EA02-025

APPENDIX N

SPEED CONTROL BRAKE PRESSURE DEACTIVATION SWITCH

Below is a proposed wiring / circuit change for the Speed Control Deactivation Switch.

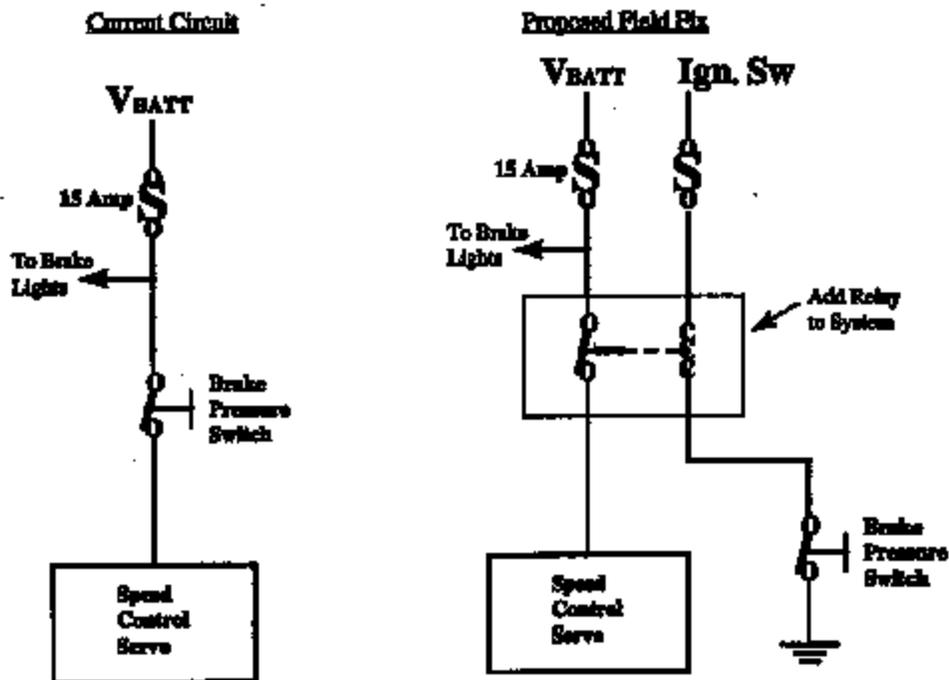
This would be a field fix for 1992 & 1993 Town Cars. The change is proposed to prevent deact switch failures. There is a potential this action could be for additional model years and vehicles lines that use brake pressure deact switches.

Please review and let me know if you have any issues. Note the Speed Control System functions do not change.

BRAKE PRESSURE SWITCH FIX

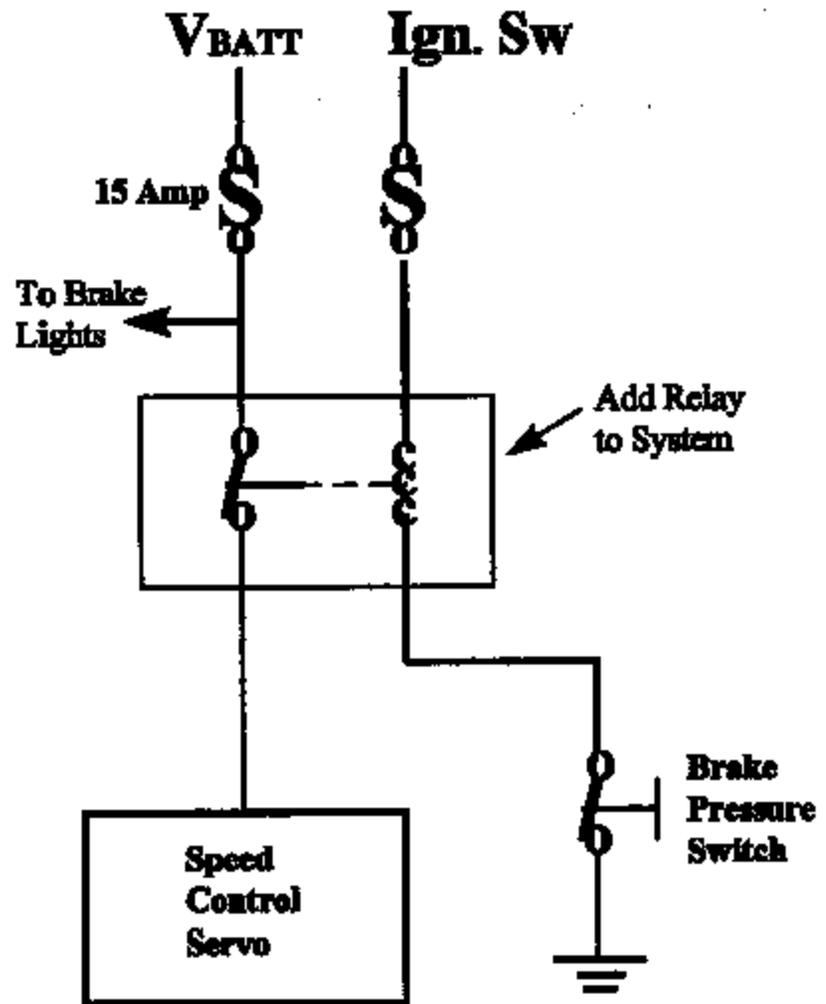
Current Circuit

Proposed Field Fix

RE: Brake Pressure Switch Circuits

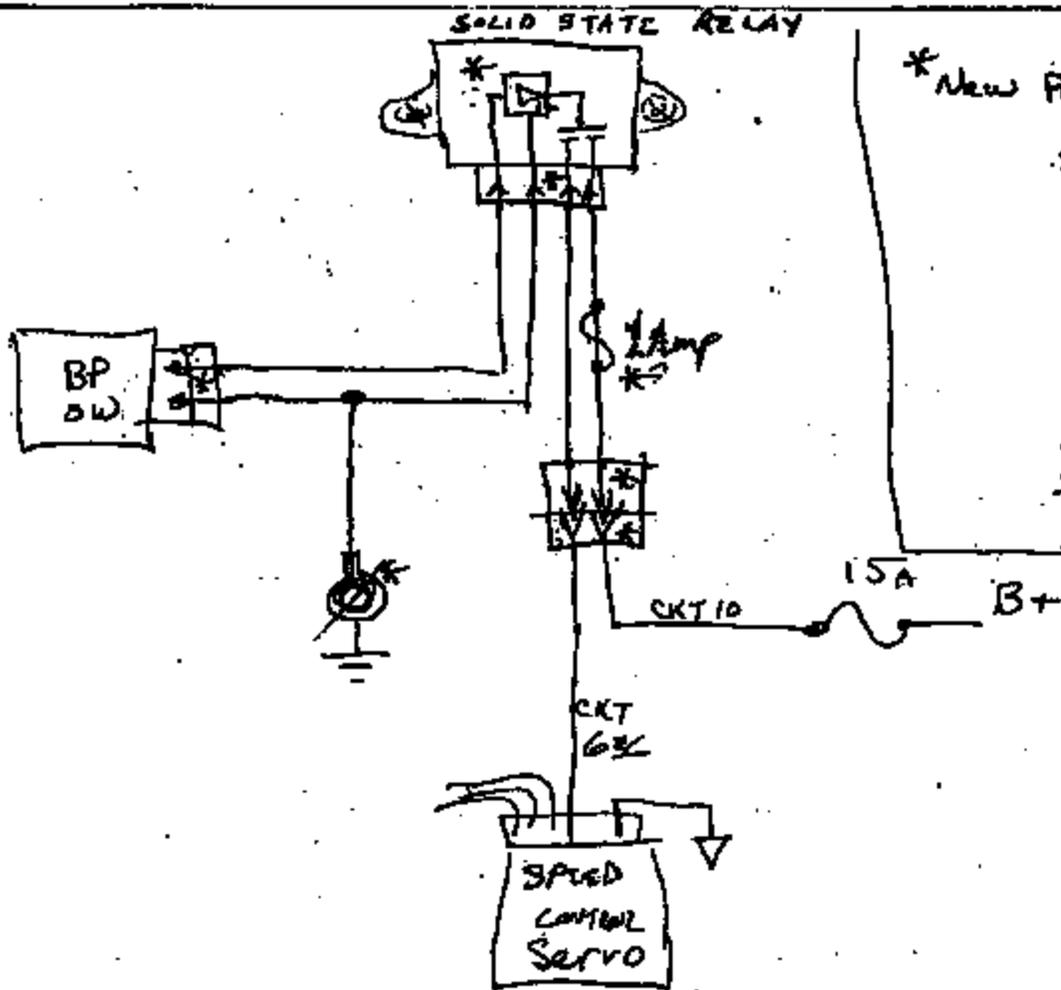
PAGE 2 & 3 show proposed circuits for moving the BP switch to a ground circuit & limiting its operating current to $< 12\text{mA}$.

The Speed Control Clutch current is supplied by a switch that is not effected by Brake Fluid. Please comment on the feasibility and suggest parts that would be useable for the relay or solid state relay.
